Barclays Cycle Superhighway Route 8 CP15 Chelsea Bridge

Safety Audit Response Report

Stage 3 Road Safety Audit

Ref: 1478/CSH08-CP15/VAR/2011RR

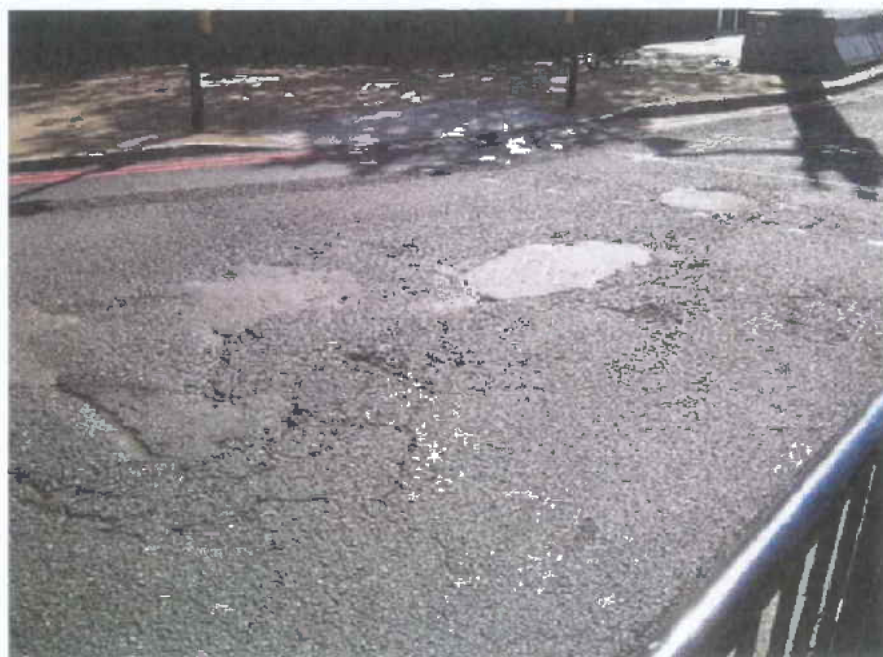
Sheet 5 of the drawings shows an area at the southbound exit from this junction which is earmarked for surface treatment. However judging from the state of the carriageway at this location it would be apparent that no remedial work has recently been undertaken. The current state of the surface constitutes a hazard particularly for two wheel vehicles.

It is recommended that the area of carriageway within the Grosvenor Road junction is treated in accordance with that as specified in the scheme.

Recommendation accepted: Agreed - carriageway work specified should be carried out following consultation and agreement with TfL.

The recommendation is accepted. The resurfacing was not carried out as part of the works due to the strict constraints on working hours and therefore the limited time available to deliver the scheme. It is proposed that the Client liaise with the highways maintenance team to agree when the resurfacing could be carried out.
